Project: Harriet Street Solar Field  
 Activity ID: 10-2022-019  
 Operation Plan for the Harriet Street Solar Farm – Doc. No. 103882  
 Former Harriet Street Landfill  
 Site 77-UDP-03-14

**Fwd: [EXTERNAL]Solar Field Project Status**

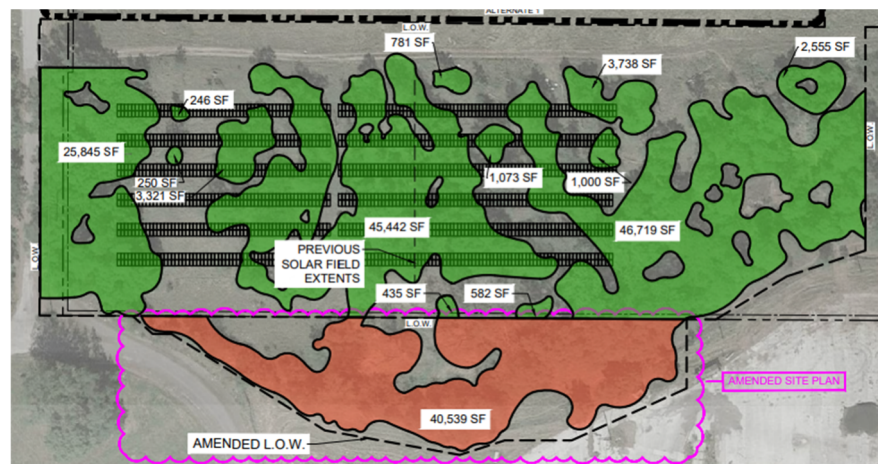
- Waste material has been removed from the site per #7 in the operational plan. Waste materials were encountered and properly disposed of by the contractor. During tree removal, grading, and seed prep, waste material was removed from the site.
- A combination of clay fill and topsoil was hauled into the site and spread over both solar field areas. This “cap” varies between 9”-18” and covers an area of approximately 5 acres.
- Additional tree removal occurred to the south of the Animal Control Facility solar array. This array area extended to the east, and the trees became a shading issue. Additional removal shown in the image below in red.
